From: ELST Master Plan <ELST@kingcounty.gov>
Sent: Thursday, January 26, 2017 10:29 AM
To: reddy@benefits-consulting.com
Cc: Lindsey Ozbolt; MikeSch@msn.com
Subject: 170126 ELST South Samm B - Reddy - ROW
Attachments: 170126 ELST South Samm B - Reddy - ROW.pdf

east lake sammamish trail

RE: King County SSDP Permit-- South Sammamish Segment B
Homeowner comments regarding 60% Design Plan
Survey Station 332+00
2221 East Lake Sammamish PL SE

Subject: East Lake Sammamish Trail Expansion and Impact Questions regarding the proposed 60% plan for South Sammamish B Segment. To be included in the public record as documented concerns against the King County trial permit application.

East Lake Sammamish Master Plan trail South Sammamish Segment B 60% review

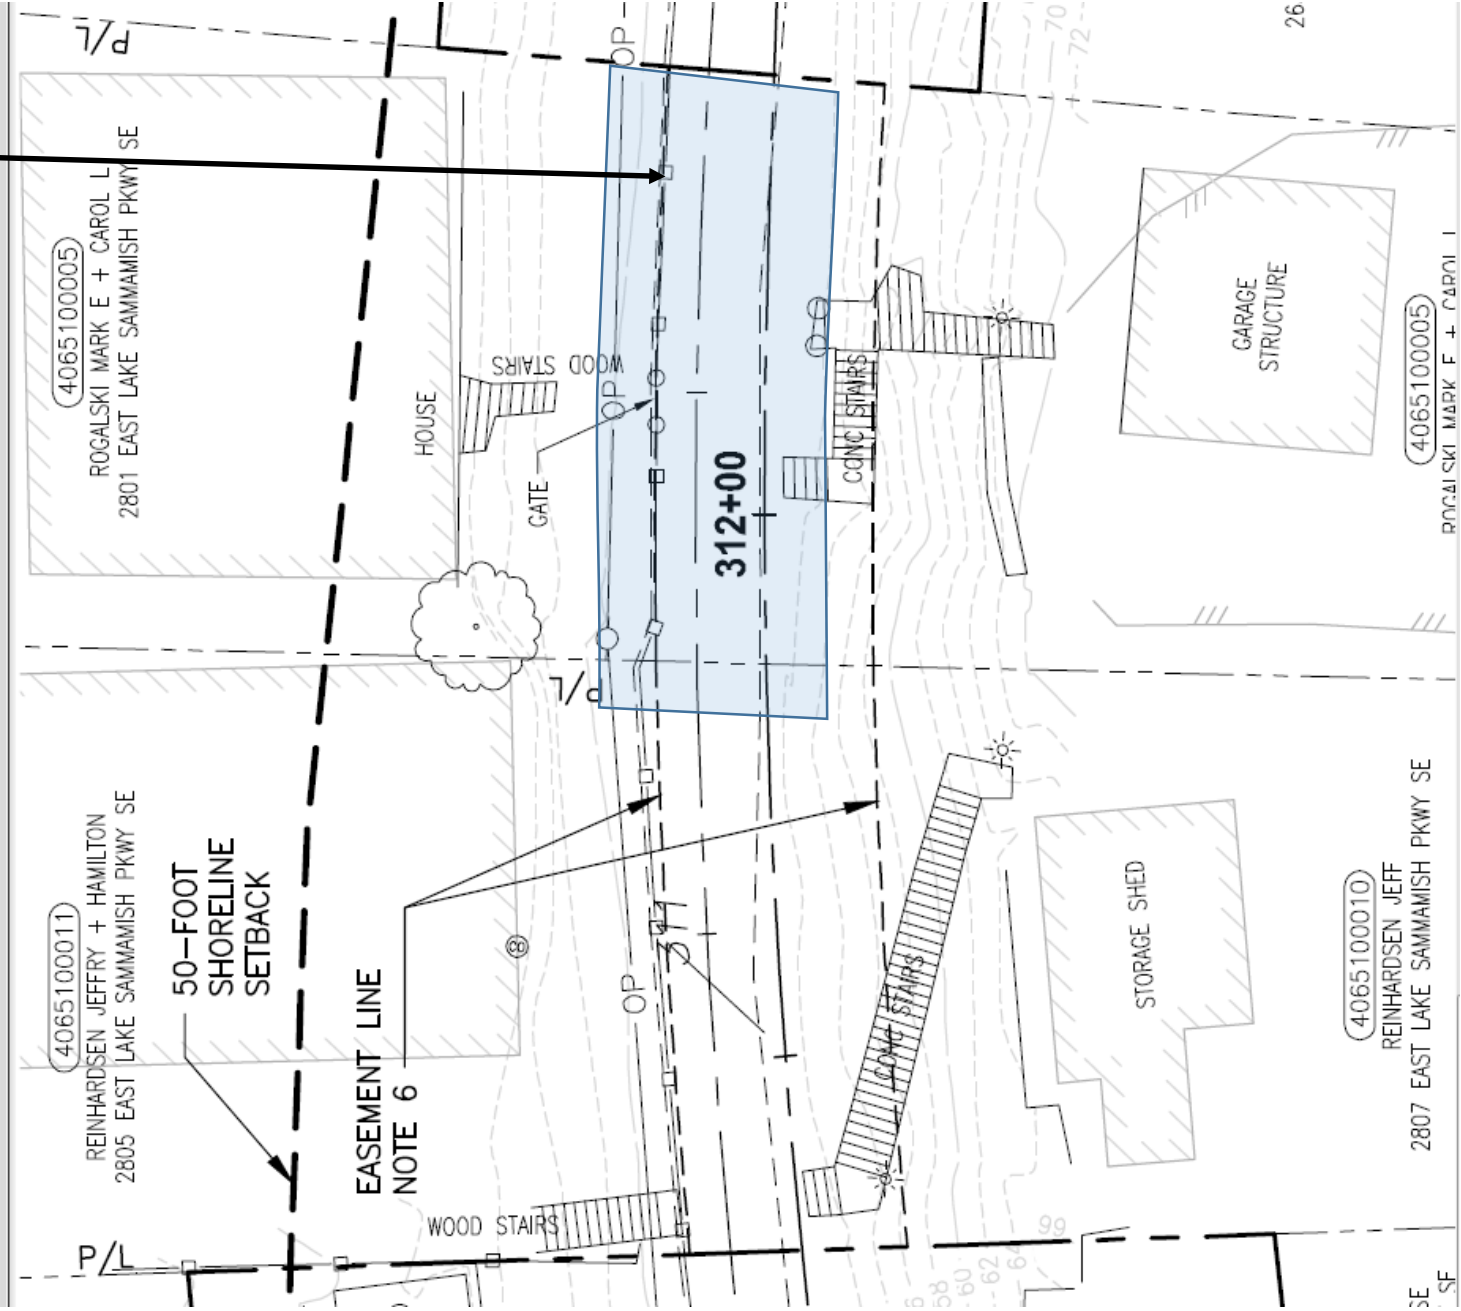
20 ft Easement not at center line of removed tracks.

Excerpts from Quit Claim Deed, March 4, 1999 easement agreement.

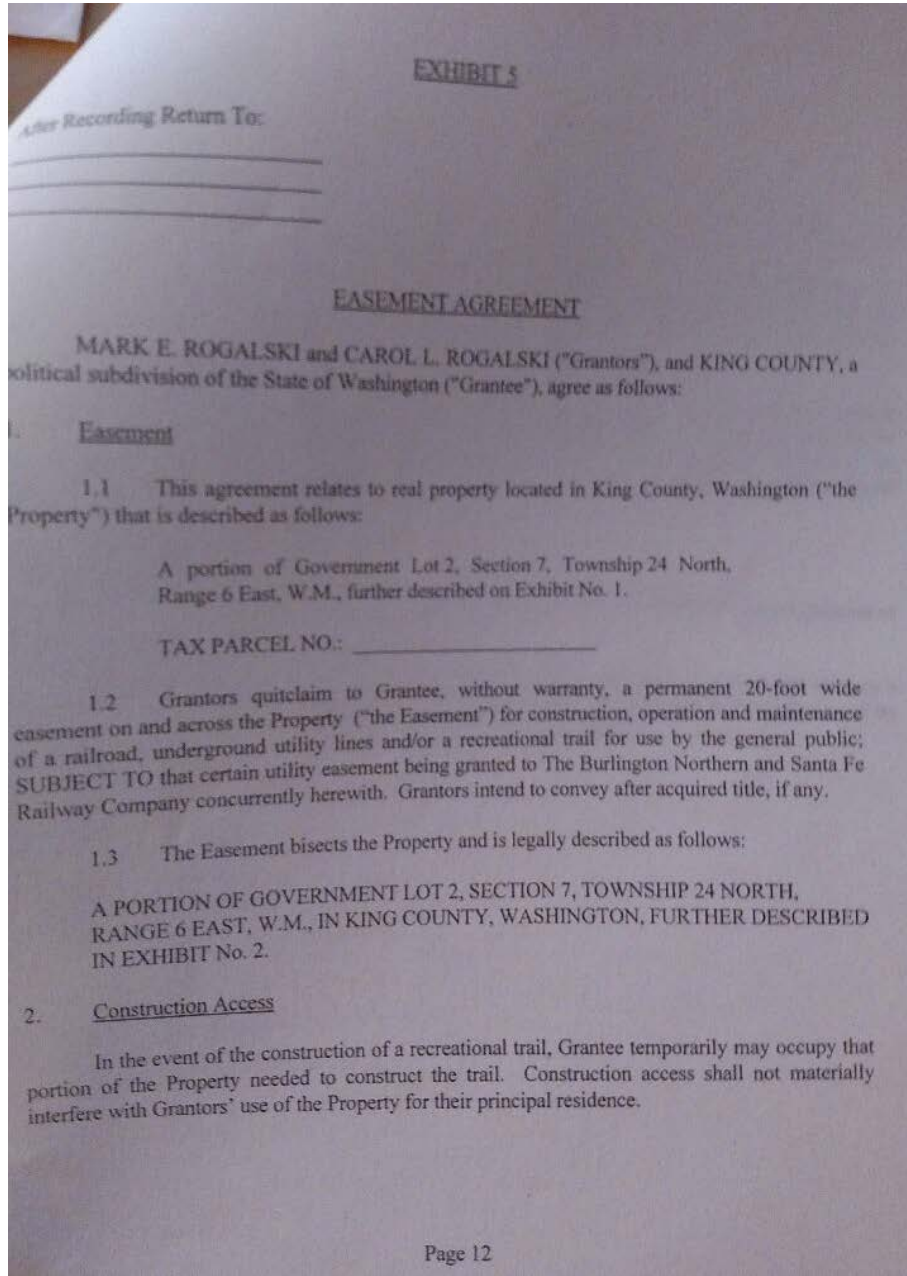
Garage floor height is at 64 ft and trail is proposed at ~ 51 ft

Excerpts from Quit Claim Deed, March 4, 1999 easement agreement. Page 13.

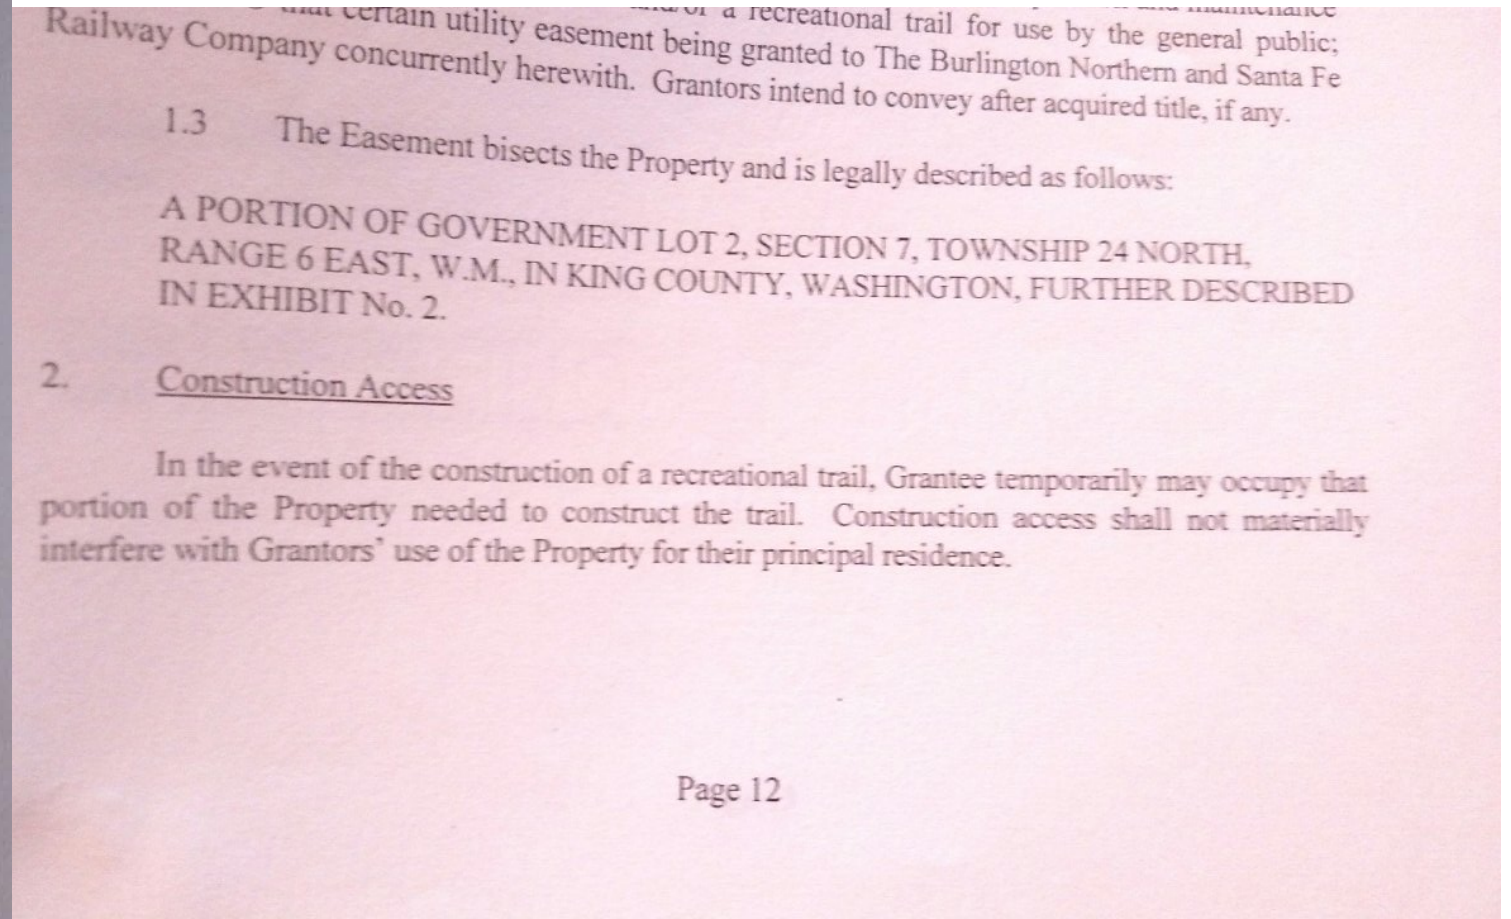
Clarify construction requirements to have access during construction of trail improvements.

Item 3.2; Clarify homeowners use of easement for emergency access and moving of large objects

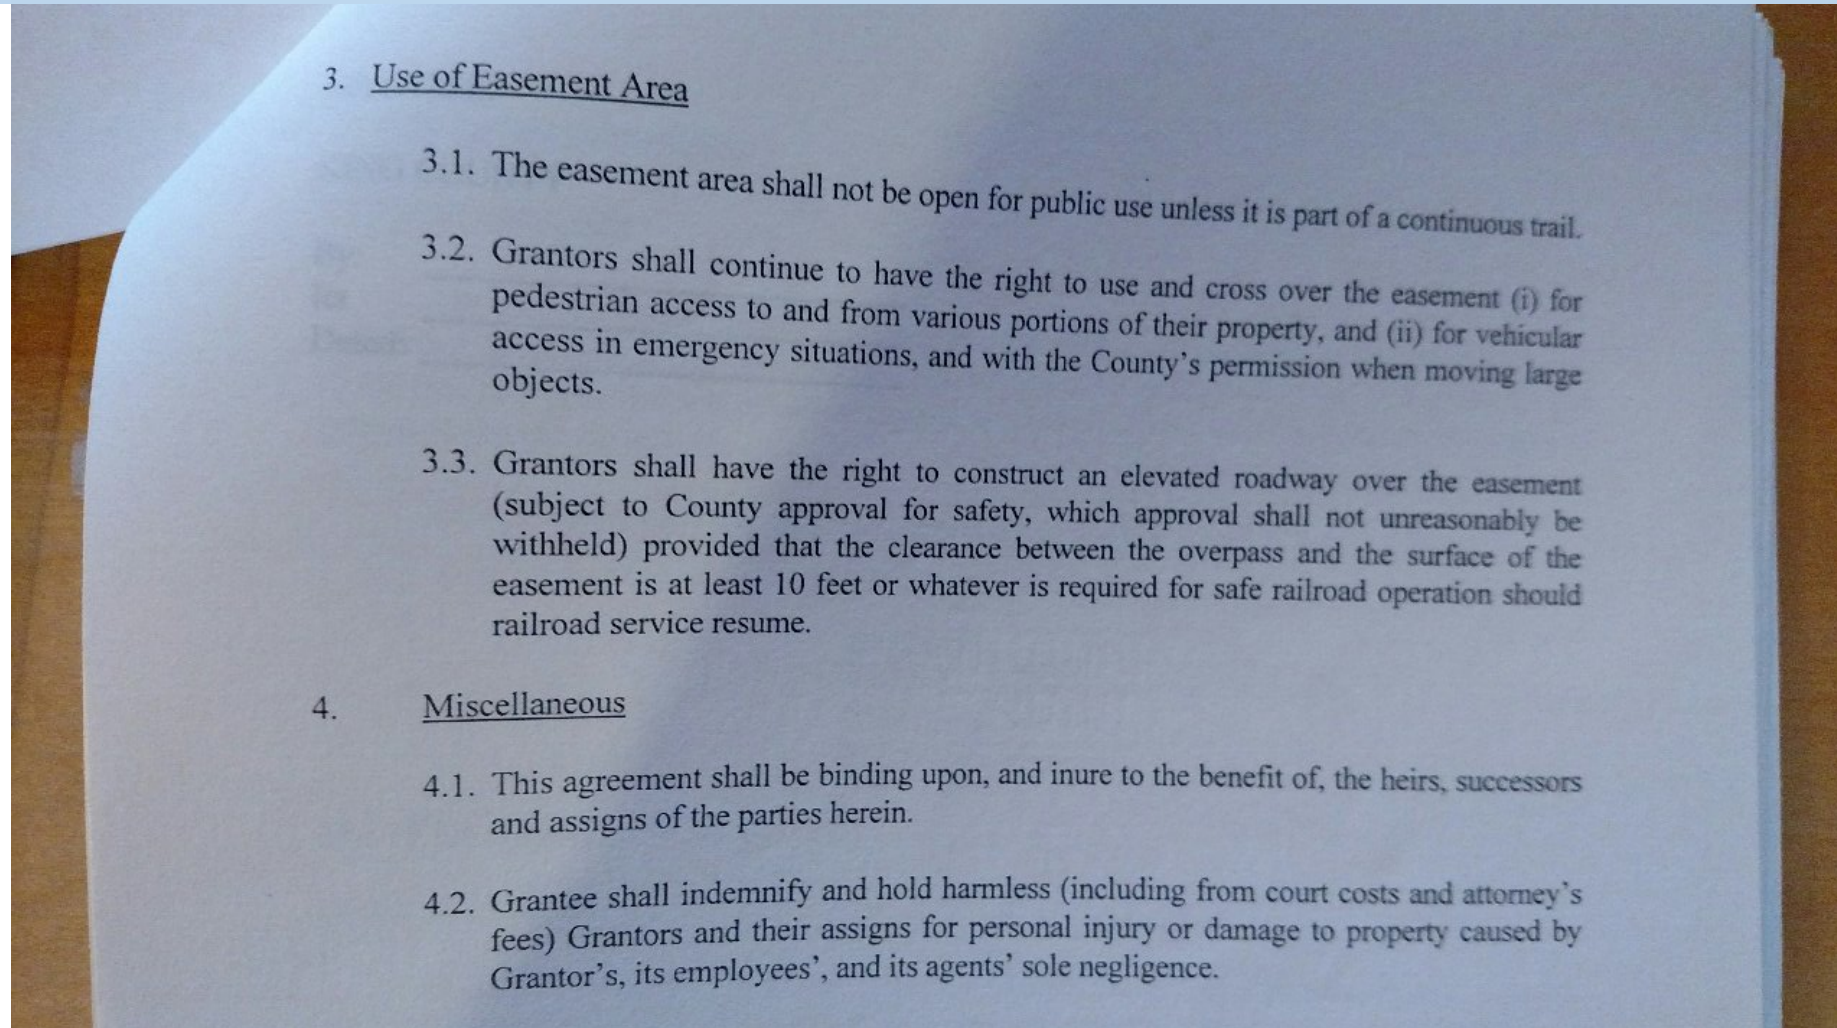
Item 3.3; right to construct an overhead roadway or walkway over the easement at a height of not less than 10 feet. Thus the mid level platform must accommodate at least this height and the weight of the bridge. Planned construction is for a 4 – 6 foot walkway Or there must be room to add in post in front of the wall to support the walkway.

Sheet 39 of 135 (East Lake Sammamish Master Plan trail South Sammamish Segment B 60% review

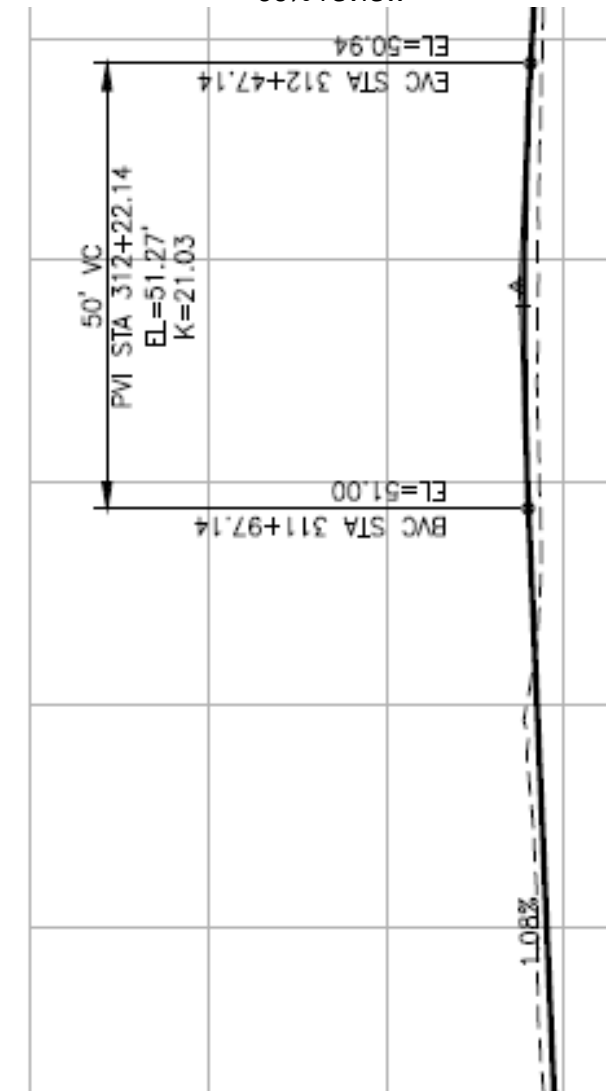
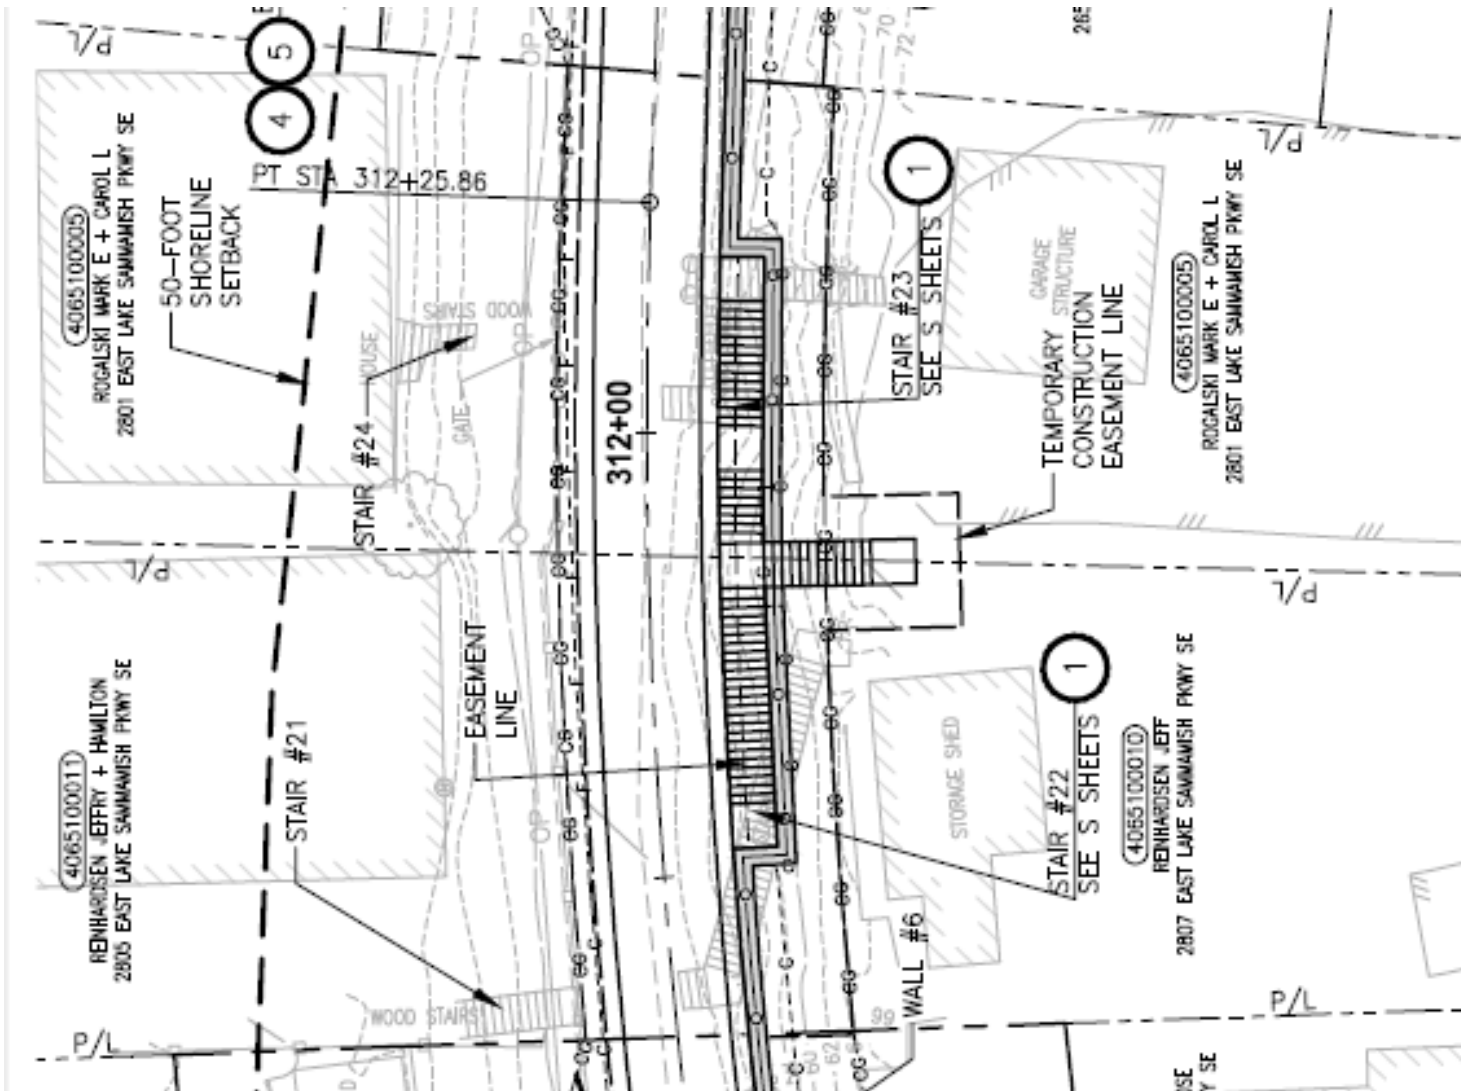
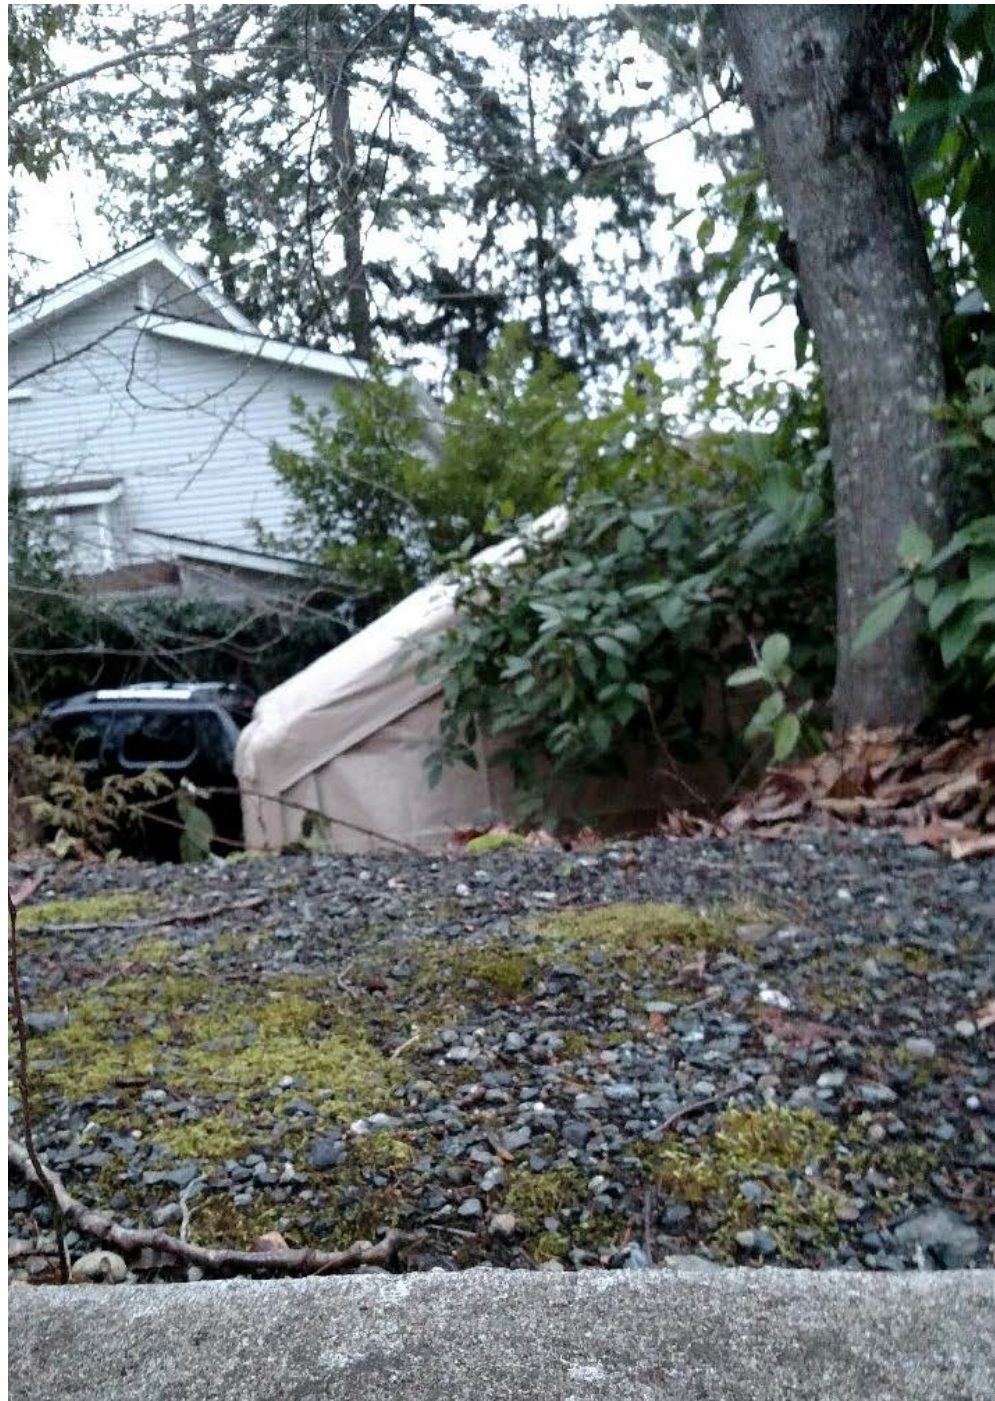
60% Plan showing only a single combined access for top elevation for two properties on property line. These are separate properties. Privacy is an attribute for these properties. Currently there is no easy access from the Reinhardtsen property to our upper garage without going way around for visitors of both households.

Gate required at trail entrance. Tope entrance needs to be separate as these are separate properties and Easements.
